Cub Crafters, Inc. Considers Compliance Mandatory

SUBJECT: UN-COMMANDED FLAP RETRACTION

MODELS AFFECTED: CC11-100 S/N00002 thru S/N00031

Figure 1

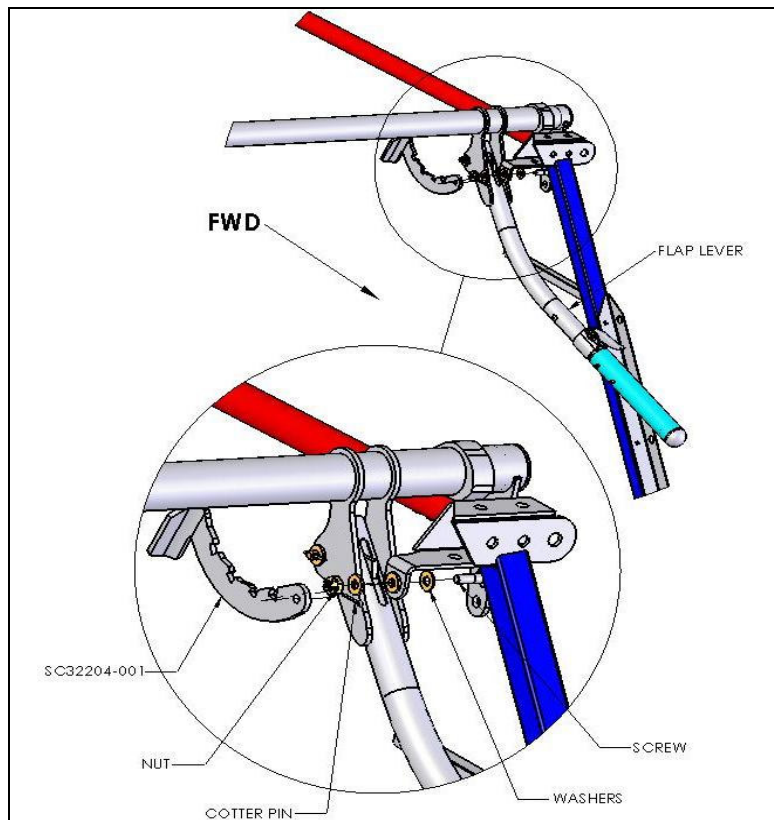
1. Remove existing SC32204-001 by removing hardware as shown in Figure 1. Retain hardware and discard SC32204-001 and cotter pin.
2. Rotate flap lever arm fore and aft while applying pressure inboard or outboard to center and align flap cross bar with fuselage centerline as necessary.
3. Install SC32204-001 Revision F using same hardware and new cotter pin (AN380-2-2). SC32204-001 should be centered thru flap lever slot (see Figure 2). Additional washers (AN960-10 or AN960-10L) may be used to shim SC32204-001 to achieve center position. Do not use more than 4 washers per side to shim.
